**REGULAR MEETING OF THE
CITY OF ALVARADO PLANNING AND ZONING COMMISSION
104 W. COLLEGE AVE.
MAY 16, 2024
6:30 PM
AGENDA**

This letter is to inform you that the attached Lone Oak Addition Phase 1 final plat application provided on April 22, 2024 has generated the recommendation of disapproval from the Alvarado Planning and Zoning Commission due to the following comments not being adequately addressed to result in compliance with the Alvarado subdivision ordinance.

ENGINEERING PLANS
FOR
LONE OAK PHASE 1
CITY OF ALVARADO
JOHNSON COUNTY, TEXAS
MARCH 2024

City Engineer Remarks on Preliminary Plat and Preliminary Engineering

LIFT STATION		PROJECT NO.
SUBGRADE & BACKFILL REQUIREMENTS		BBC010
LONE OAK, PHASE 1		SHEET NO.
City of Alvarado, Johnson County, Texas		LS-08

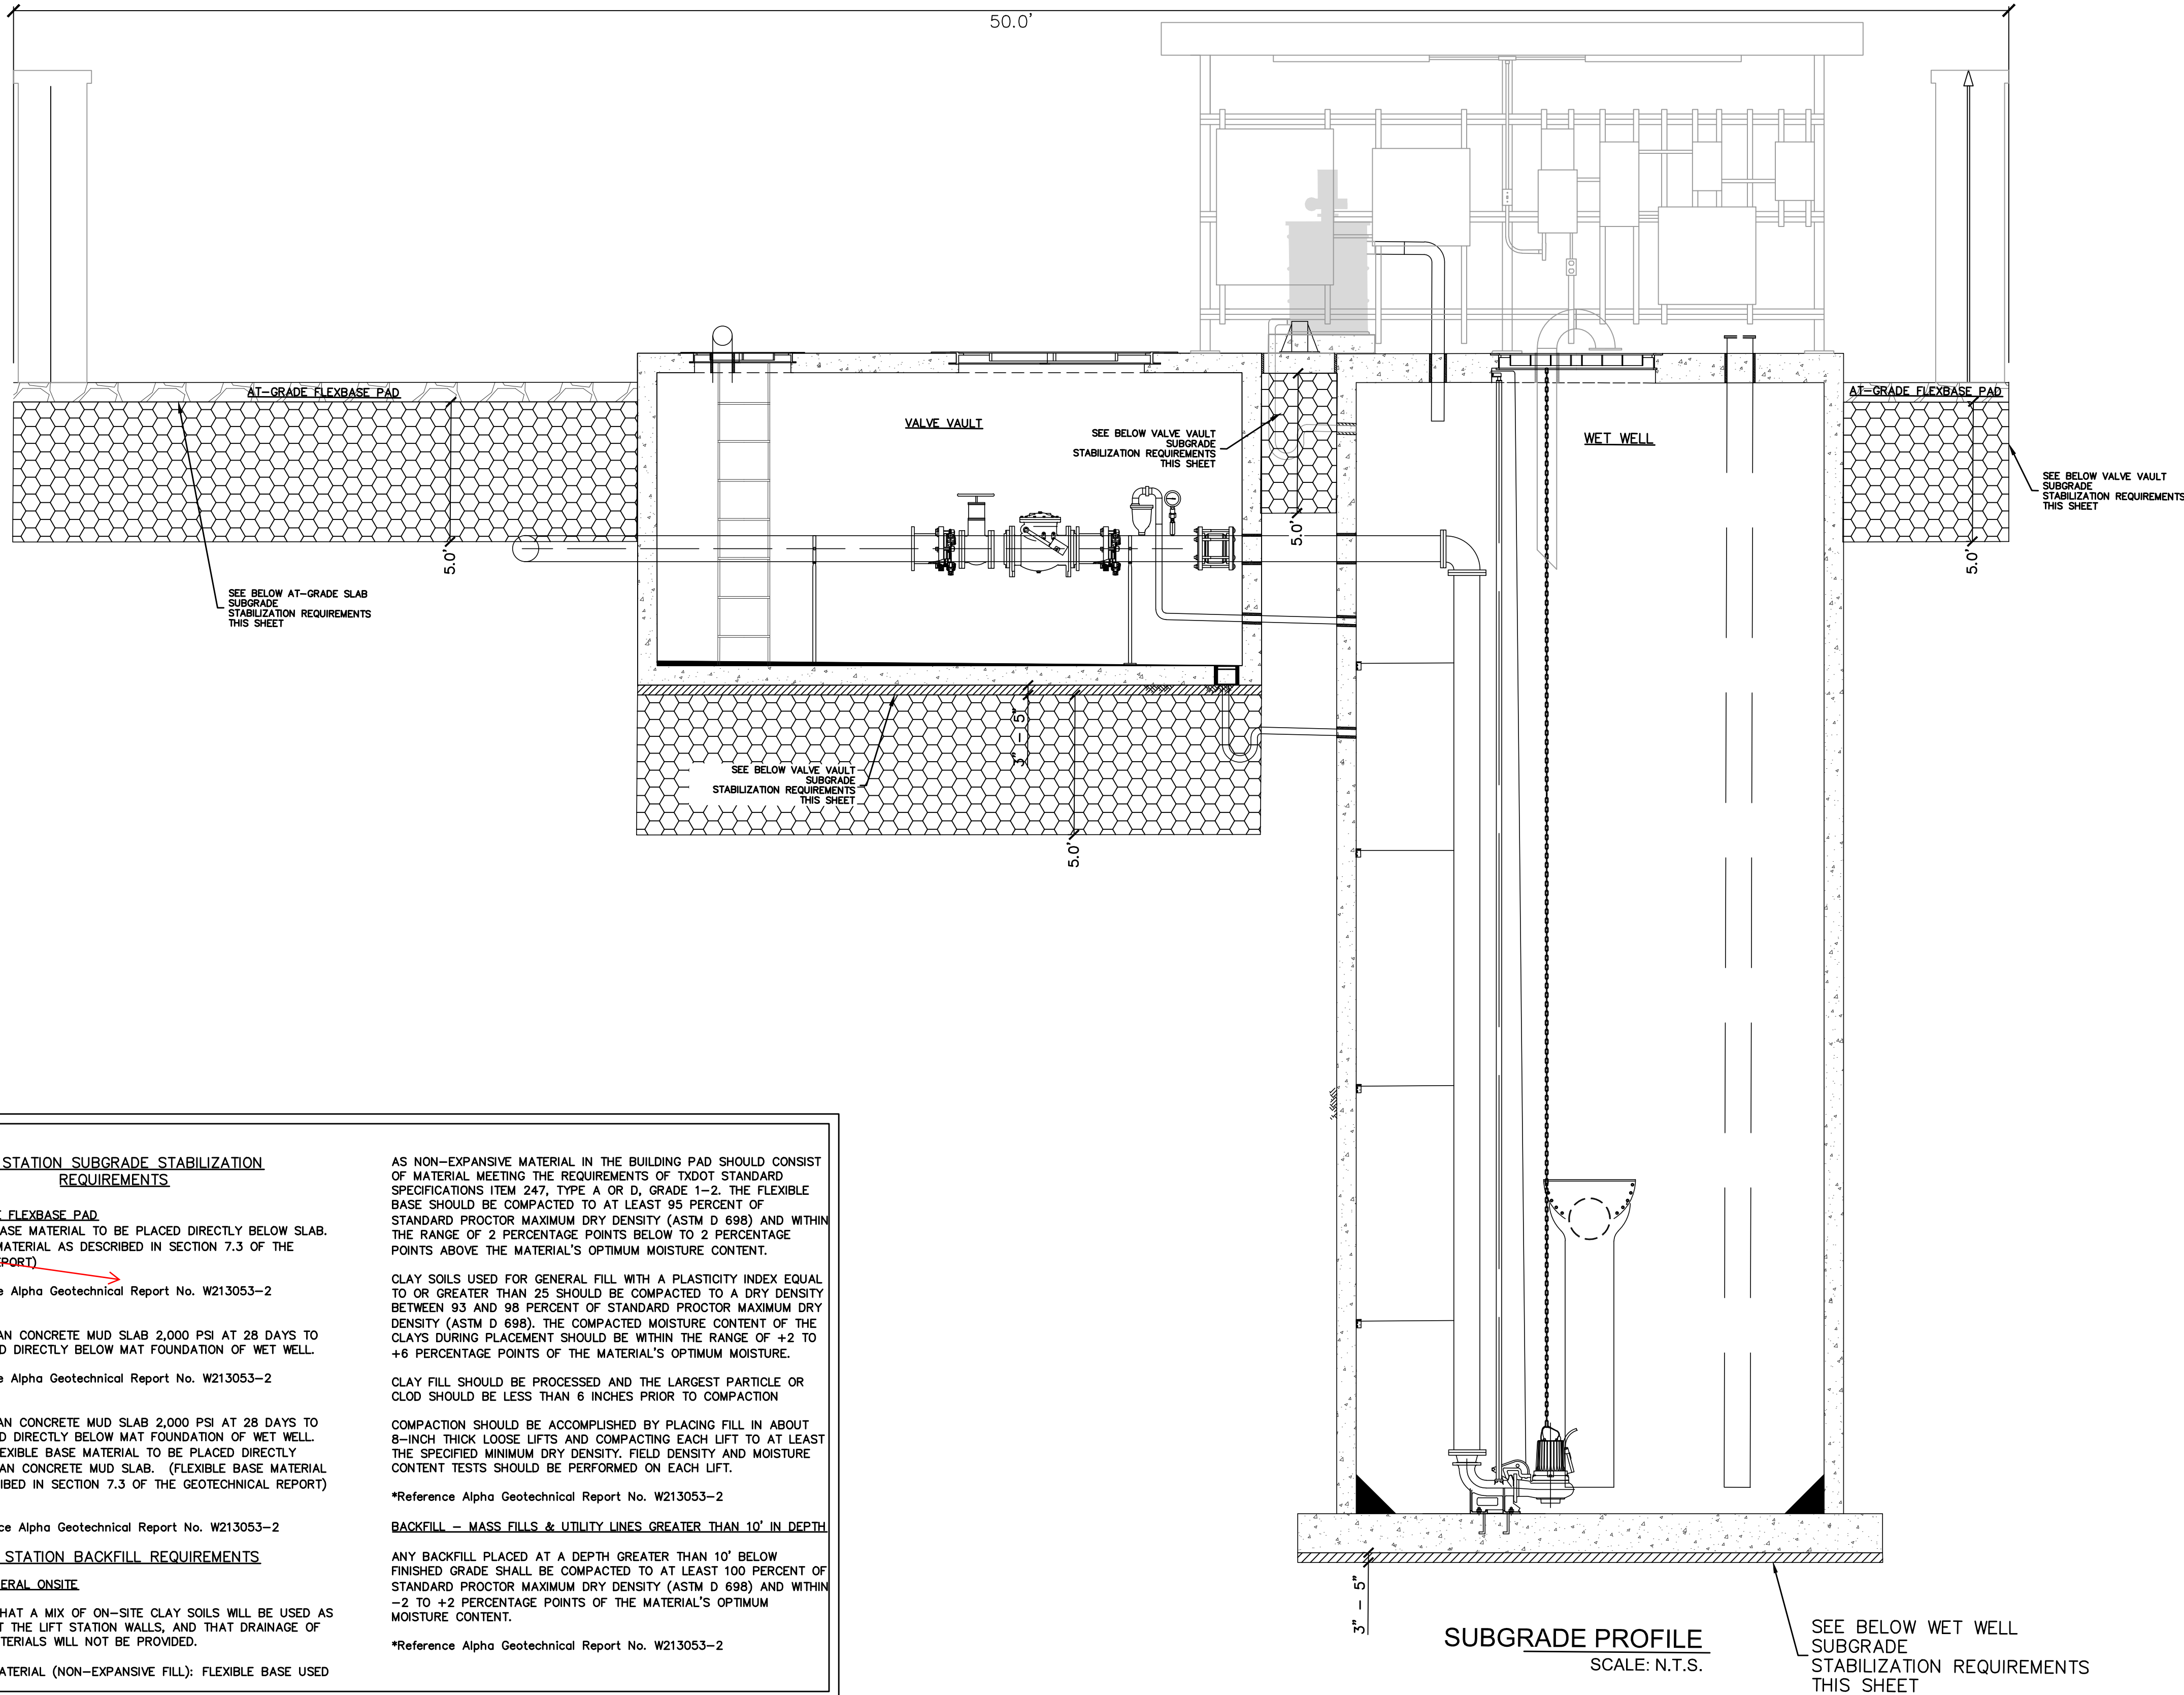
Submit geotech report.

LIFT STATION	PROJECT NO.
SLIDING GATE DETAILS	BBC010
LONE OAK, PHASE 1	SHEET NO.
City of Alvarado, Johnson County, Texas	LS-11

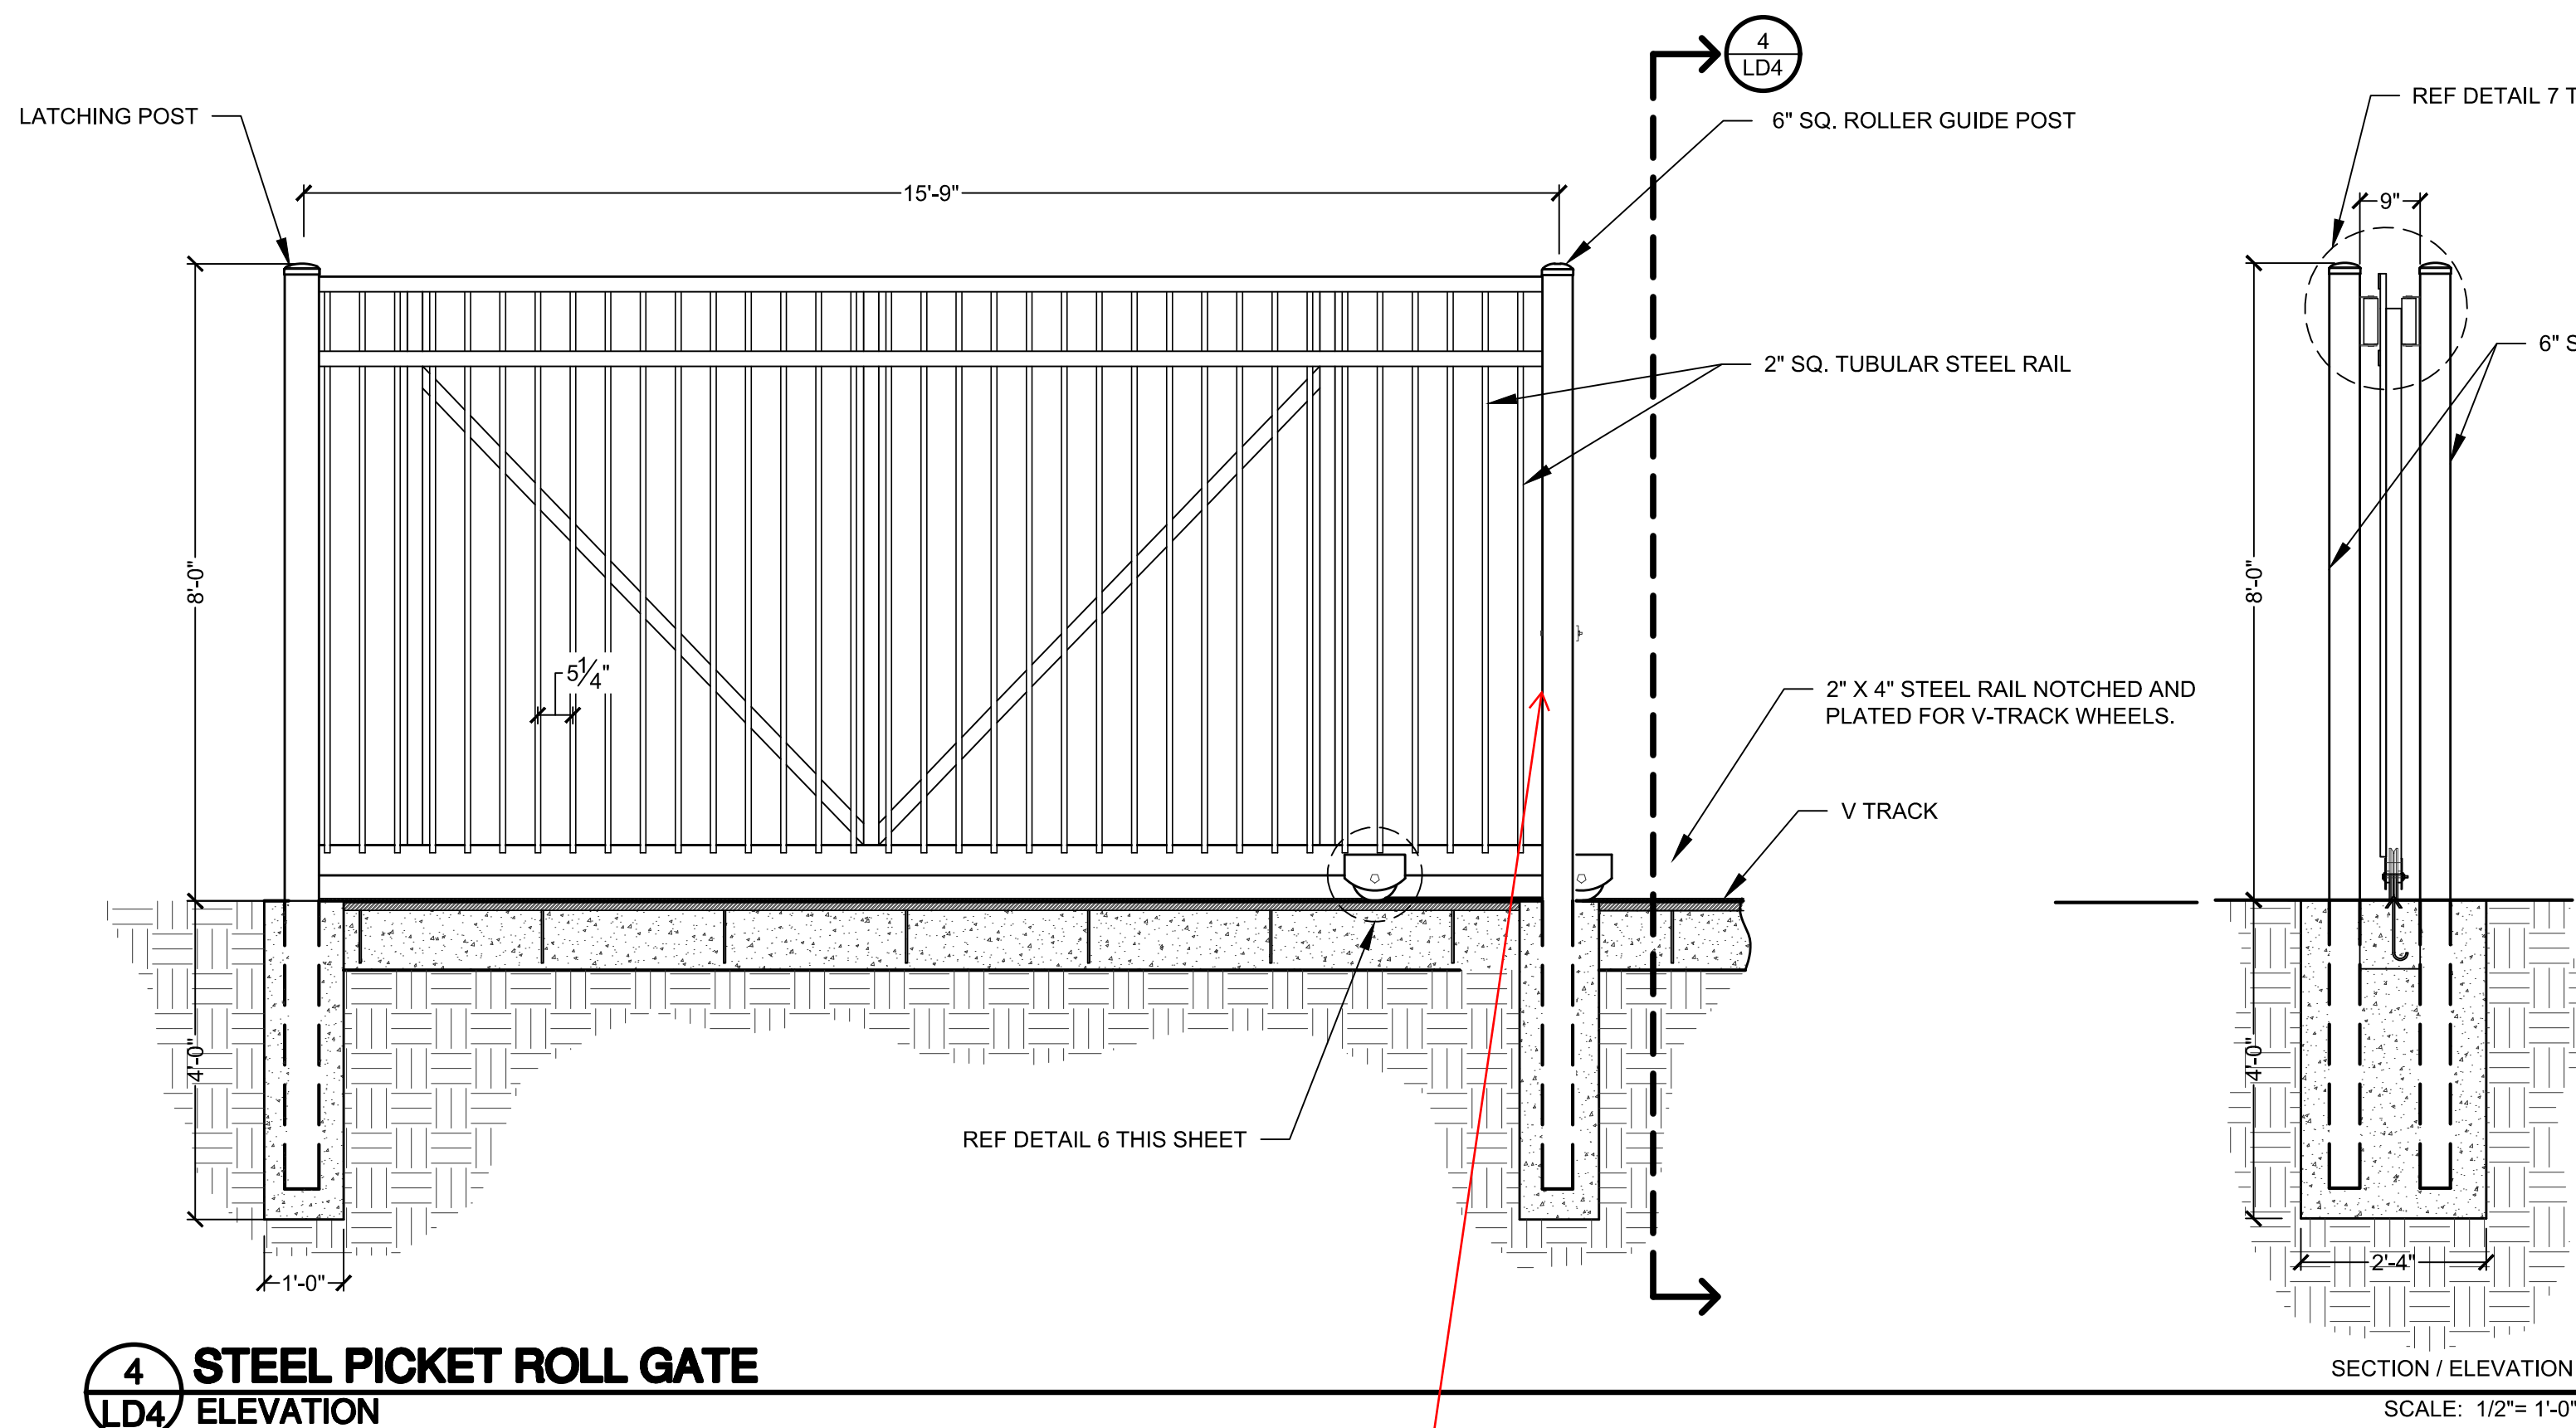
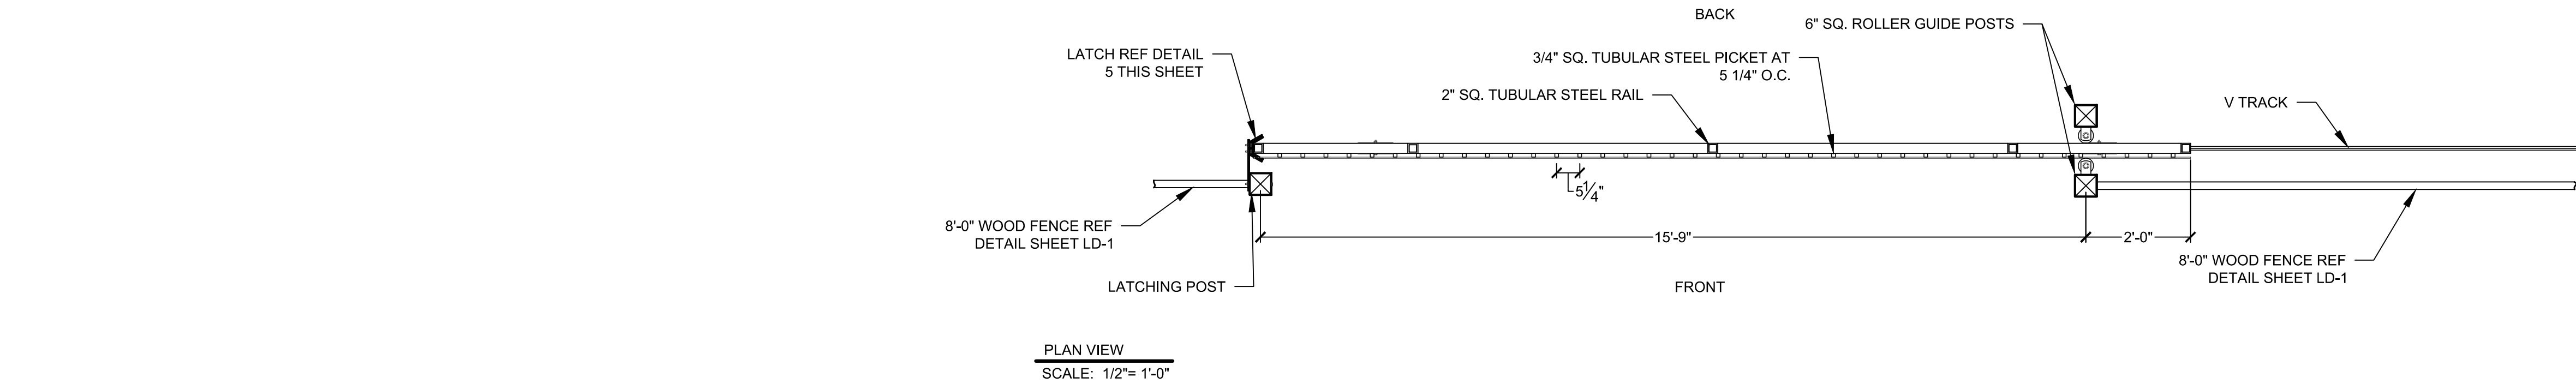
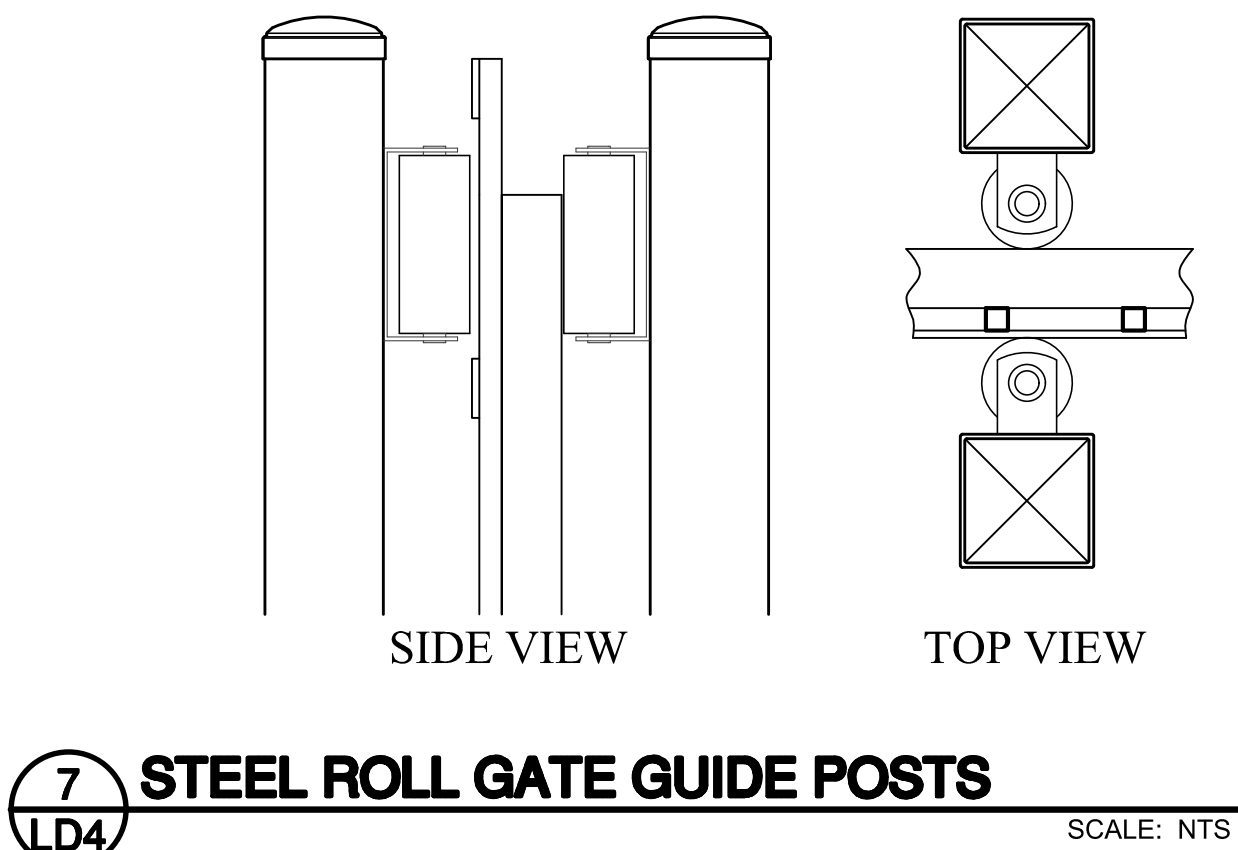
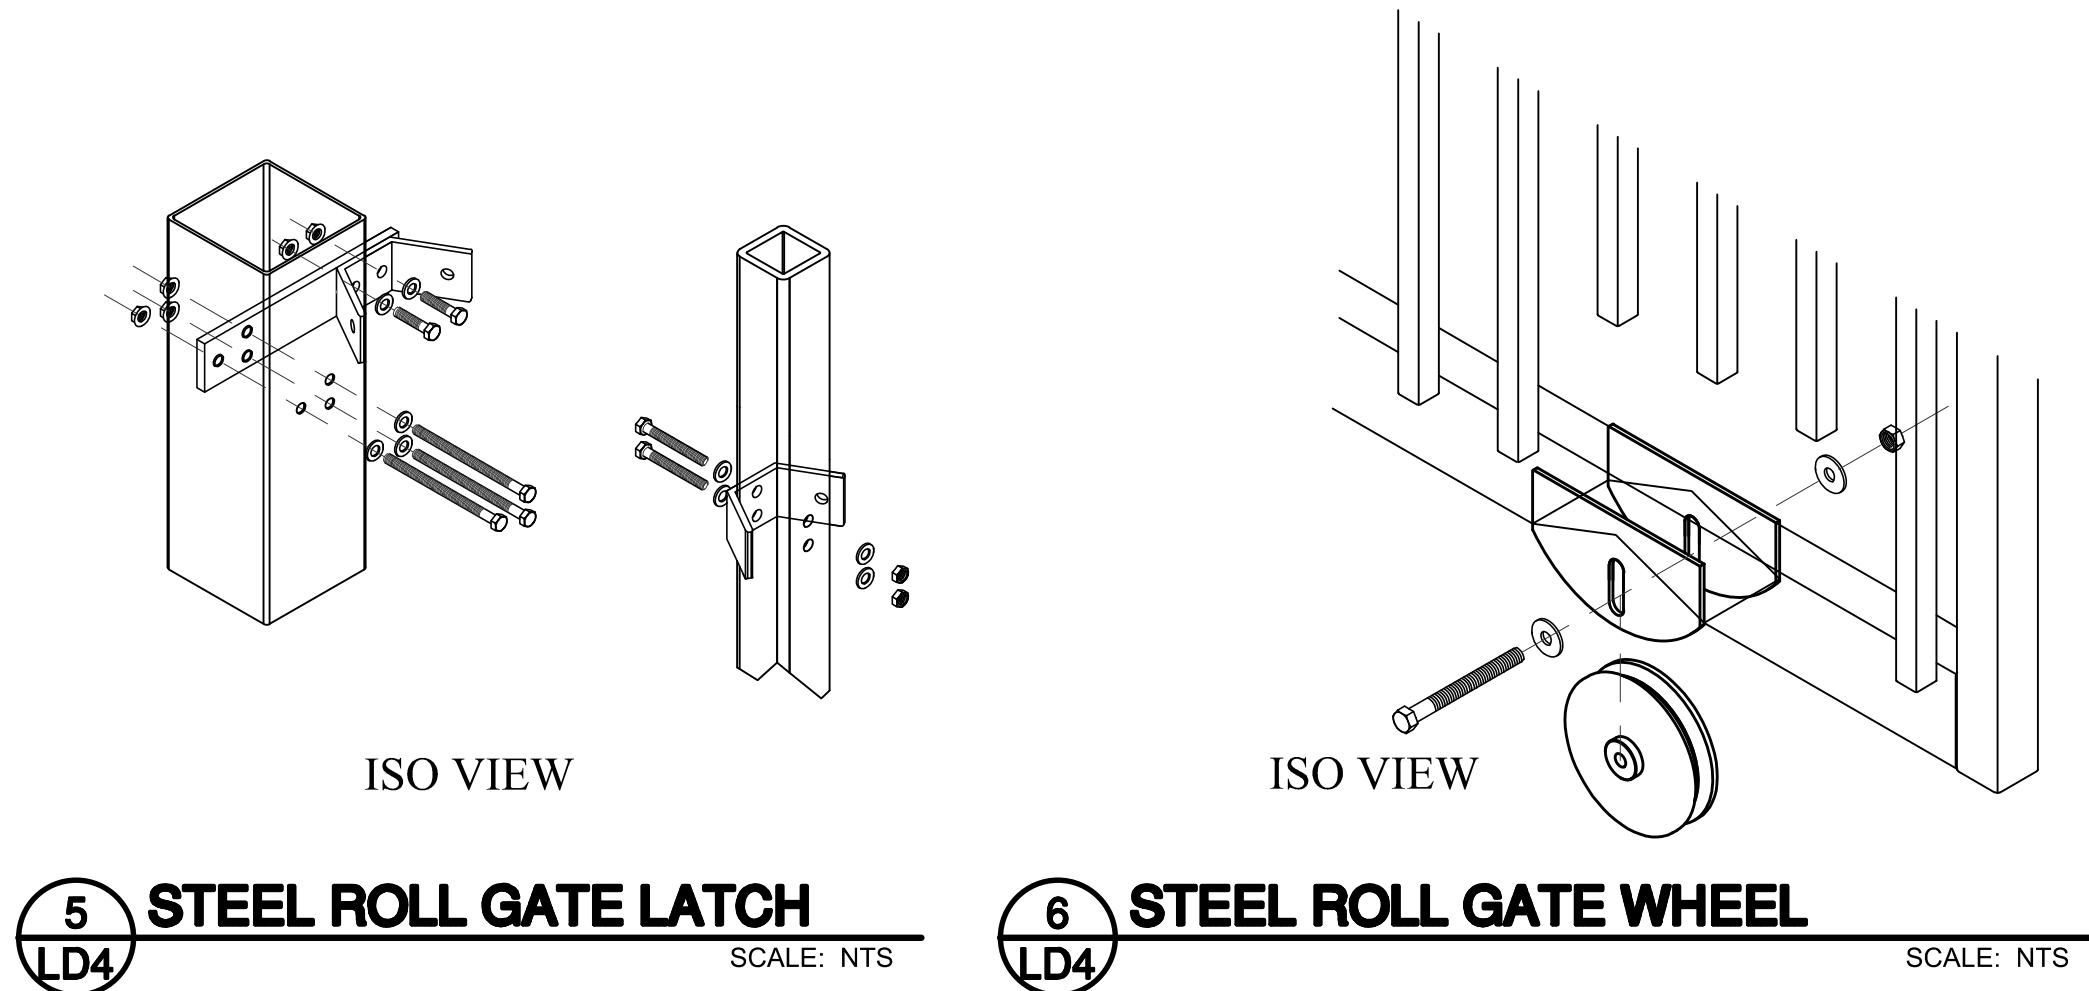
Include locking rings
for padlocks
